RE: 9328 Highland Road- Commercial Building with Drive Thru – Final Site Plan and Final Engineering Plan - 1st Review

Subject: 9328 Highland Road
Final Site Plan Review
Zoned: General Business (GB) District

9328 HIGHLAND ROAD
PROPOSED COMMERCIAL BUILDING
WITH DRIVE-THROUGH

DRAWING:
C-1

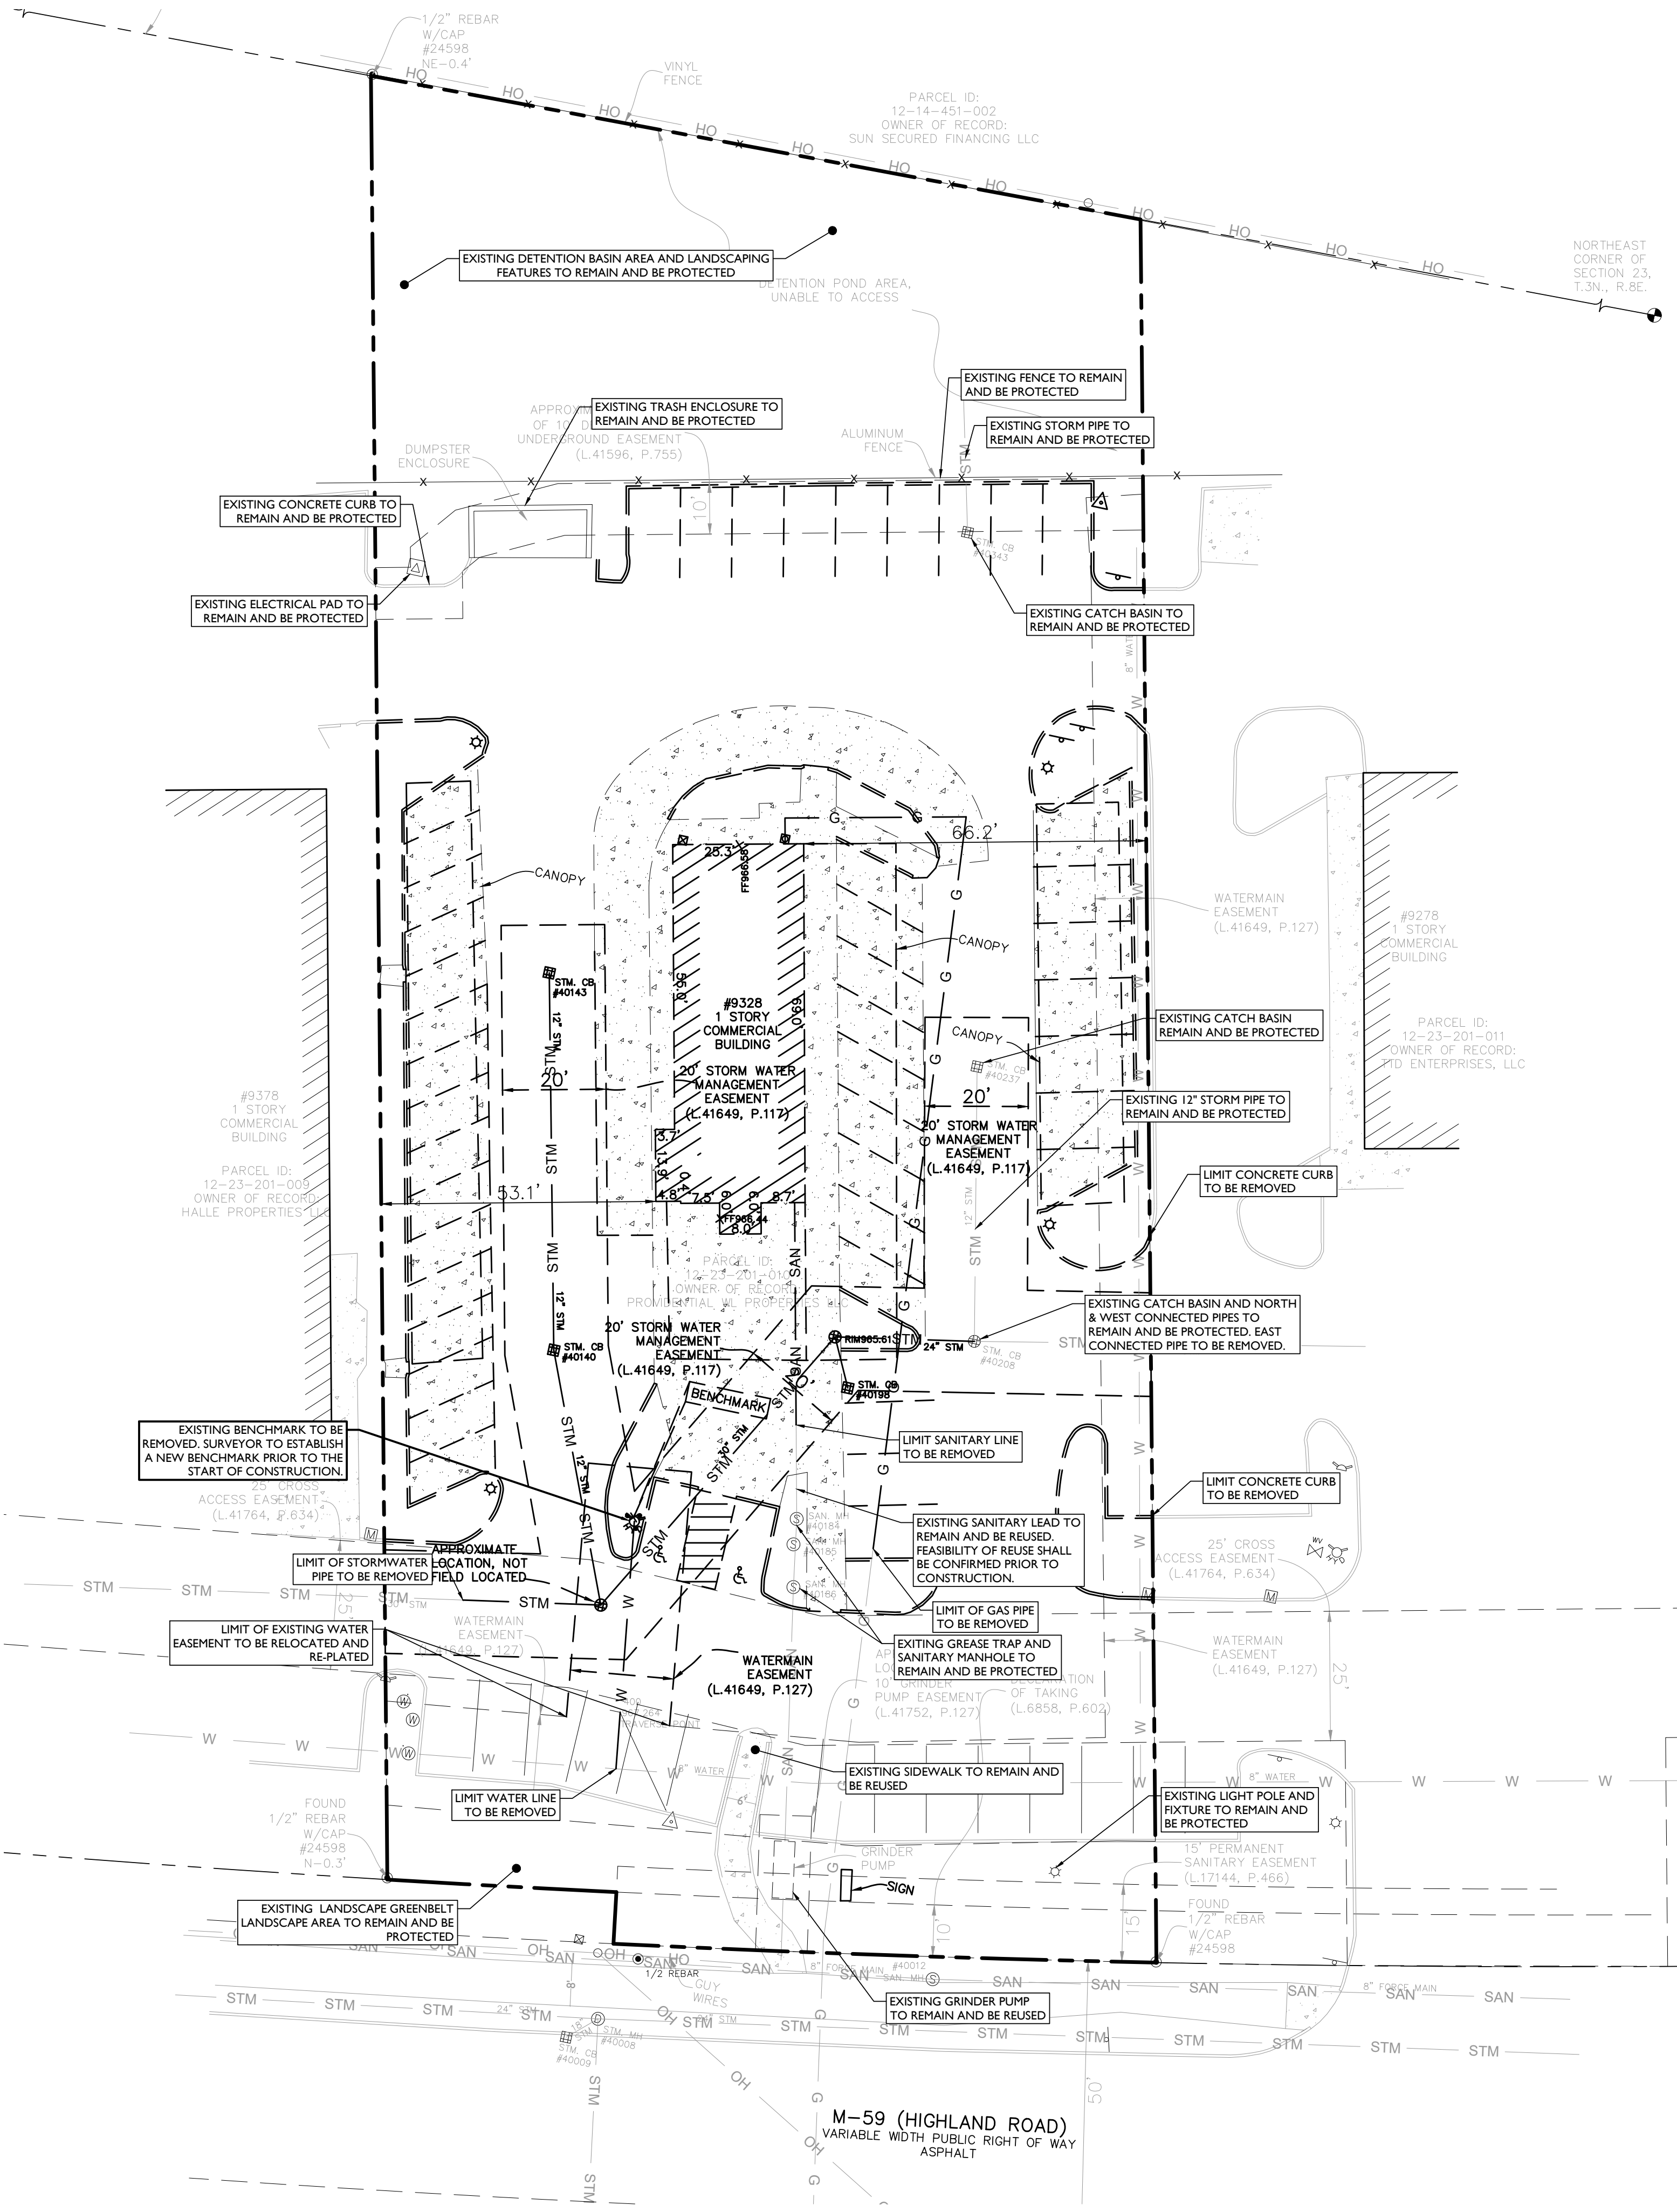
1. The parcel ID number is in error on the cover sheet. Please revise.
2. Provide notes from WLT Engineering Design Standards section A.8.a.-d. on plan.
3. Attach WLT Standard Details Sheets to plan.

DRAWING:
C-2

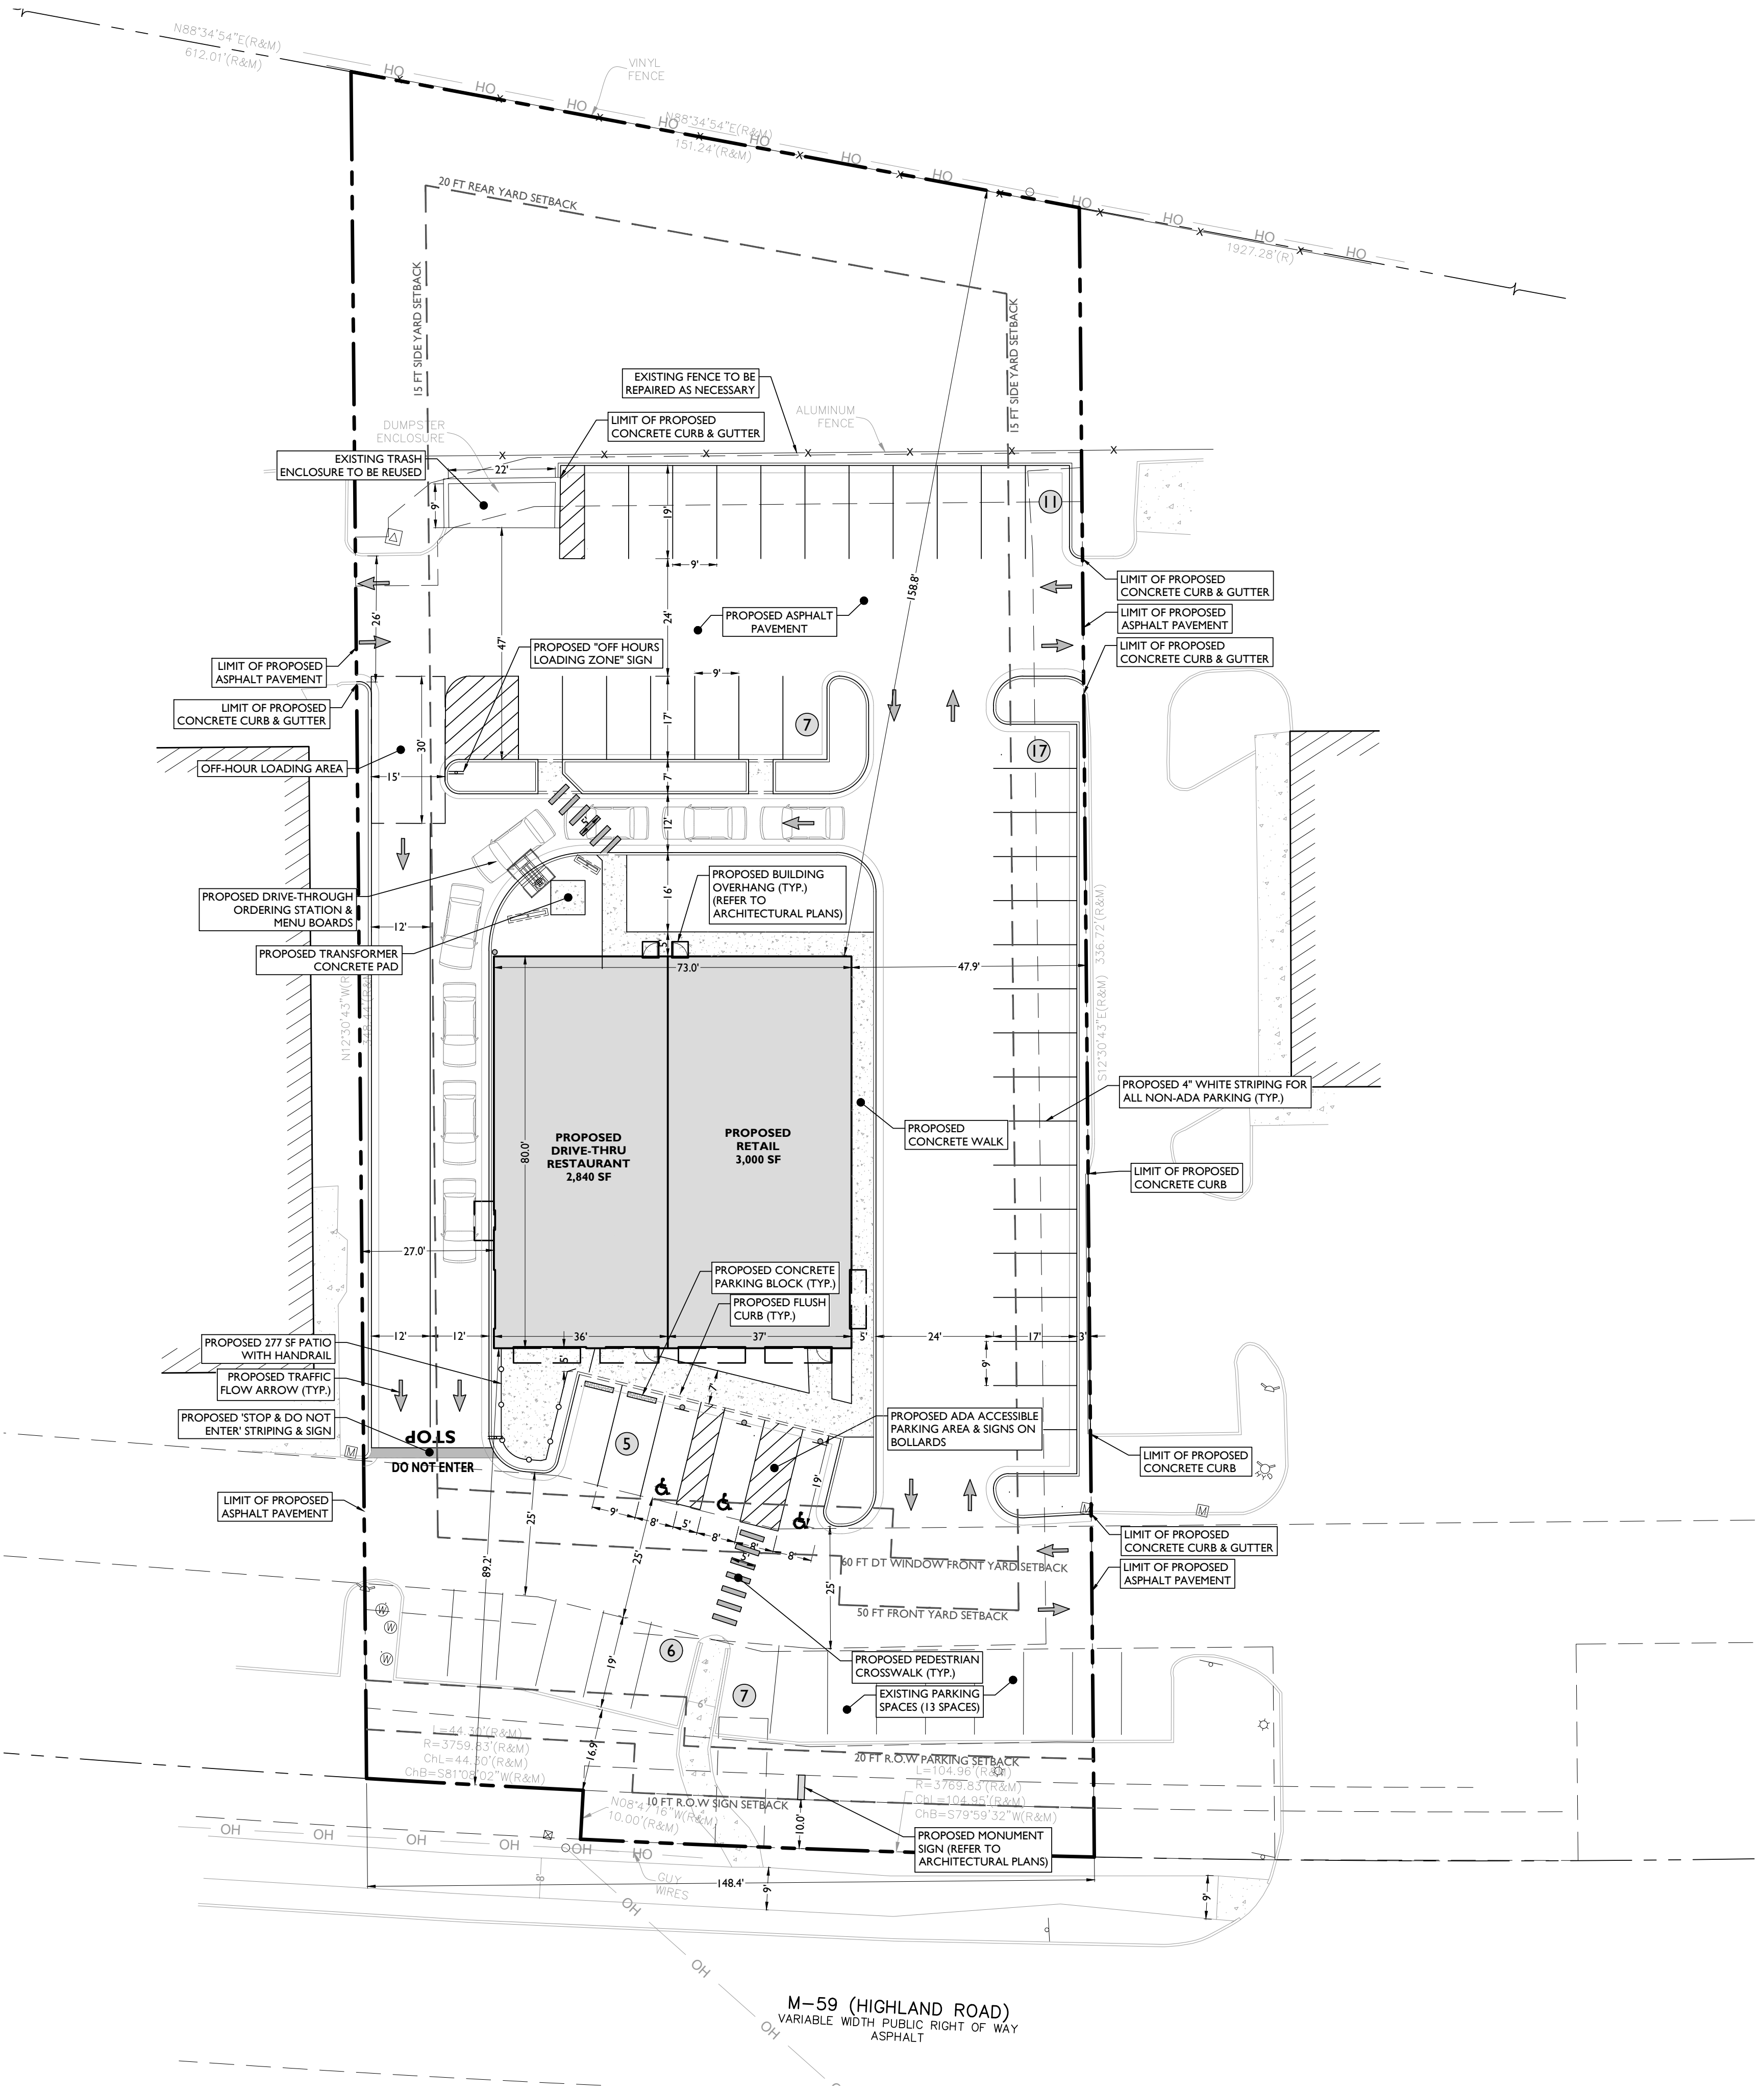
2. The existing watermain easement, where the hydrant and watermain are proposed to be removed, will need to be vacated. **Comment remains as a notation. A note to this effect has been added to Sheet C-2.**

3. The existing storm sewer easements, where the existing storm sewer is to be removed, will need to be vacated. **Comment outstanding. Please add a note to Sheet C-2 with regard to this.**

DRAWING: **C-3**

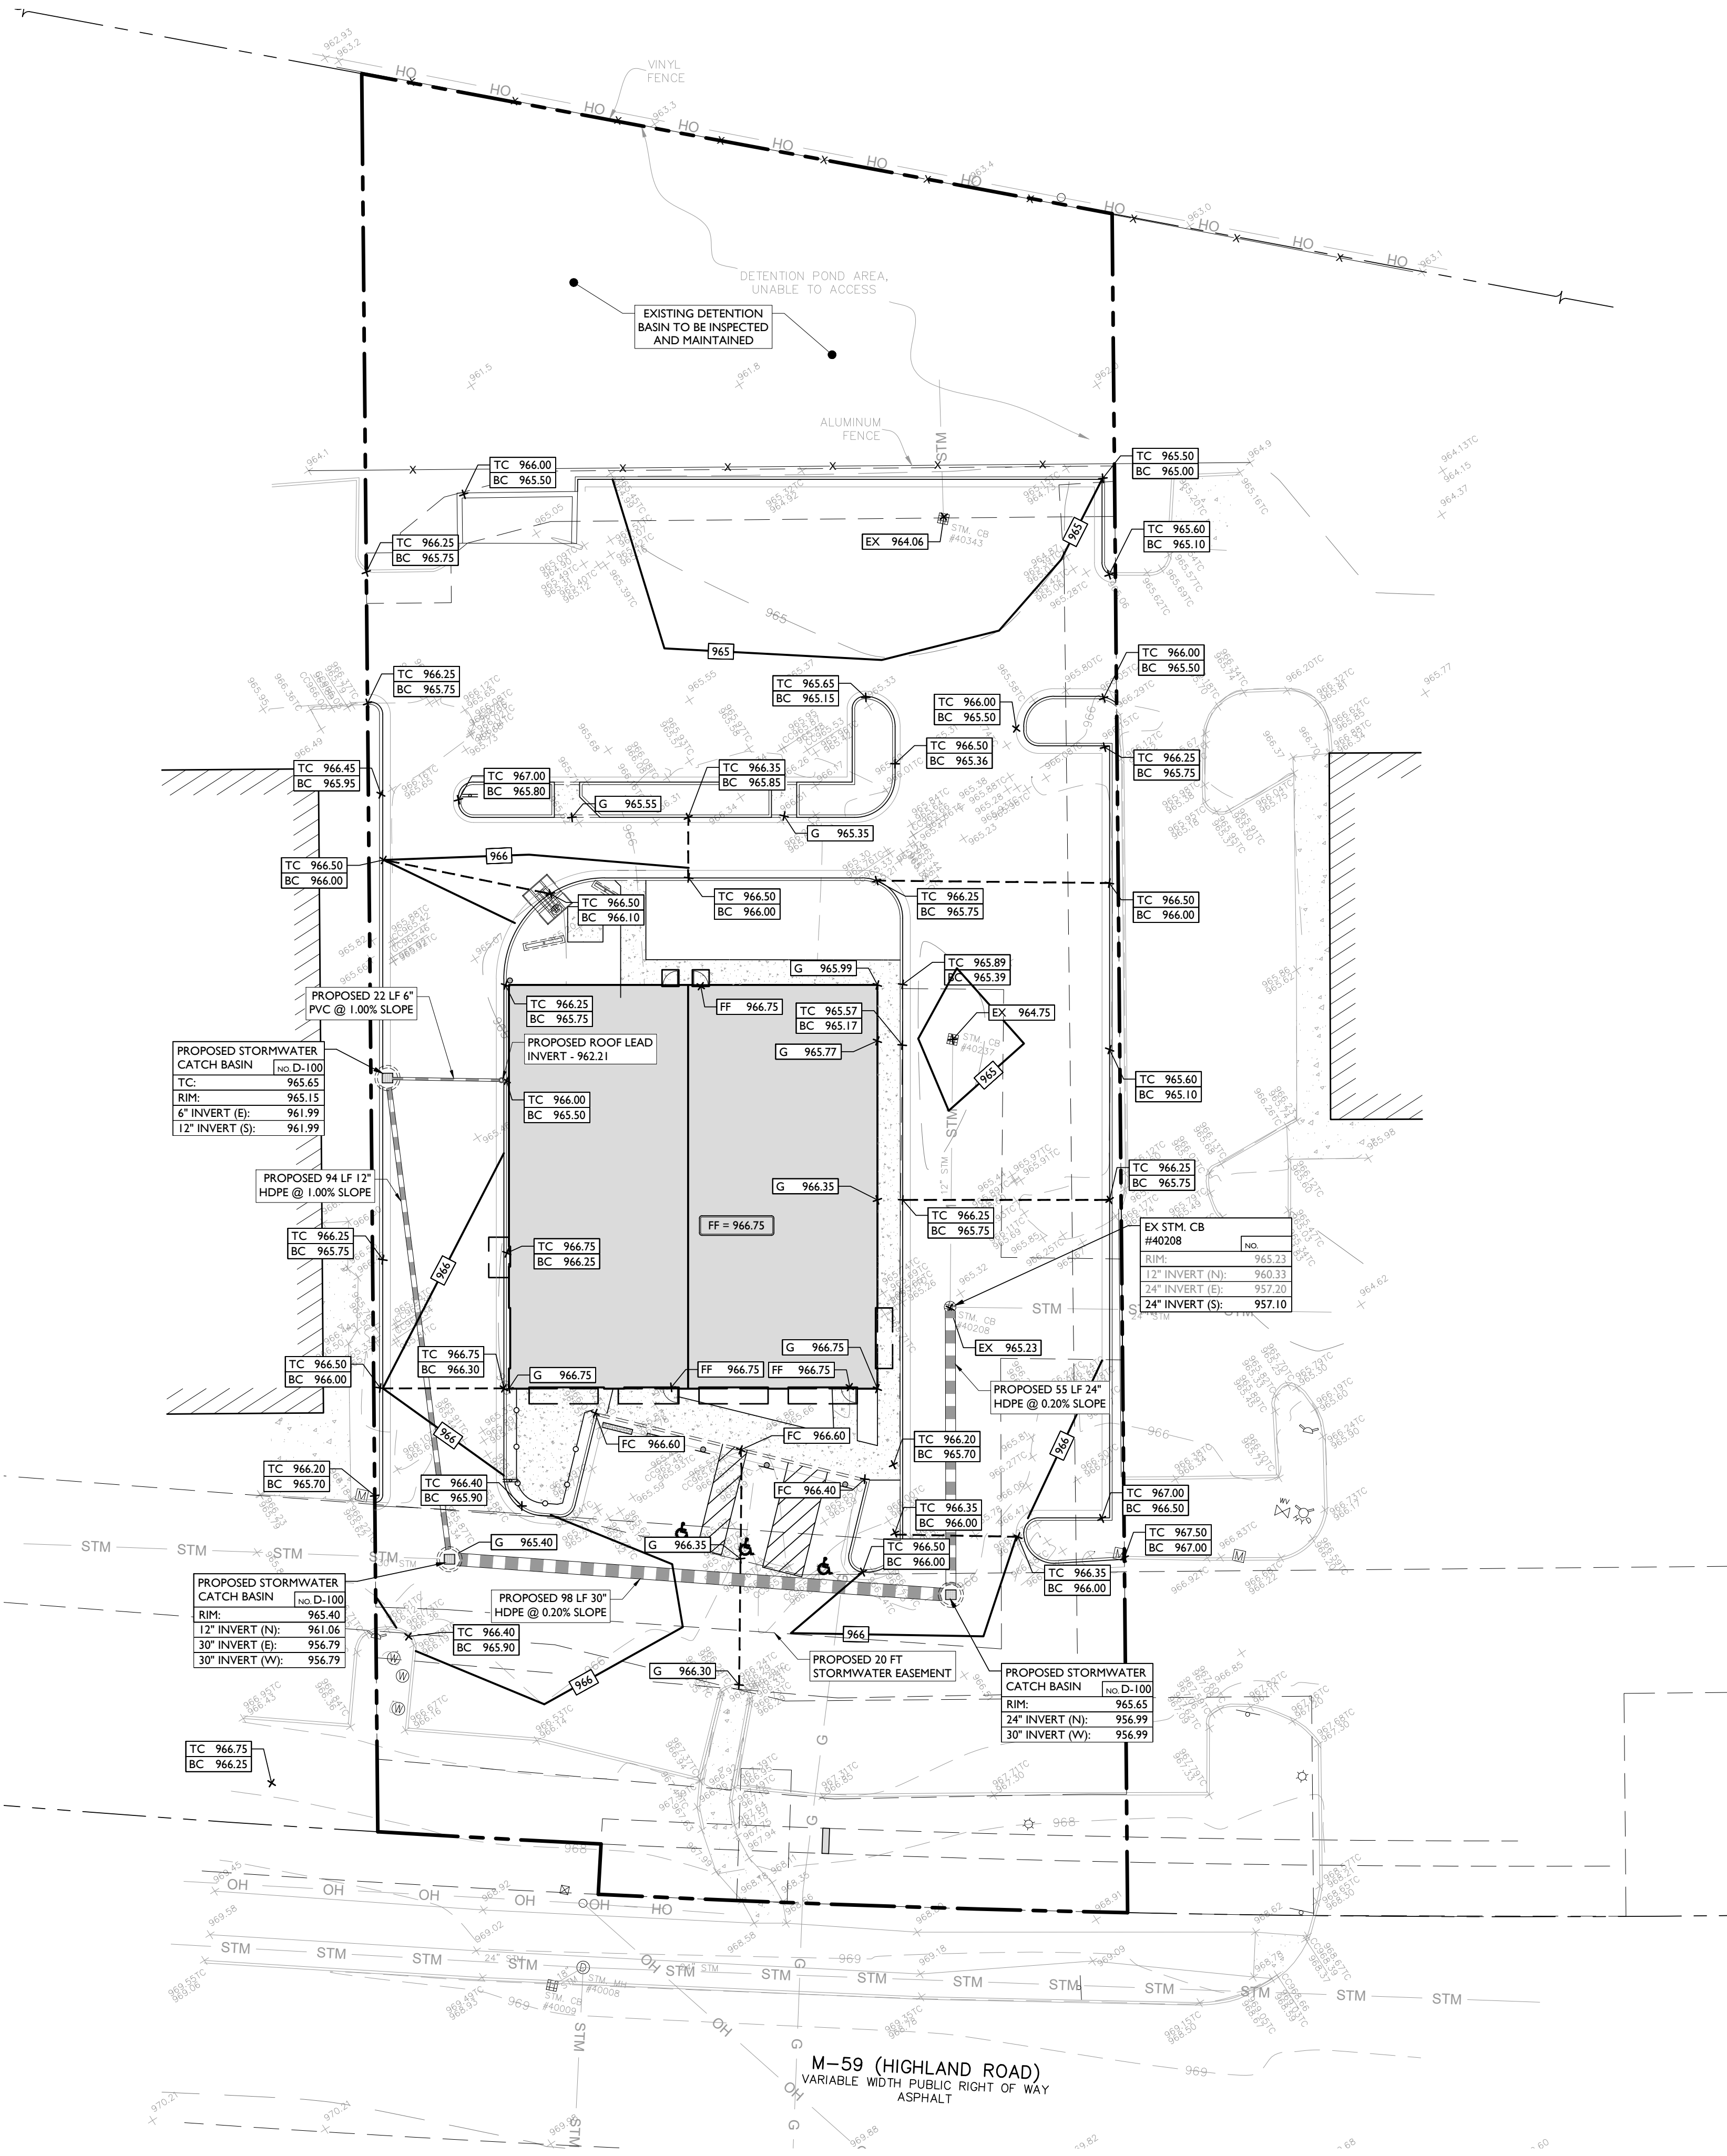
15. A site inspection showed that the white, metal fence in the rear of the site is in need of repair. A note should be added to this effect on the final site plans.
Noted on the site plan, sheet C-3

The width was increased, as shown on sheet C-3.
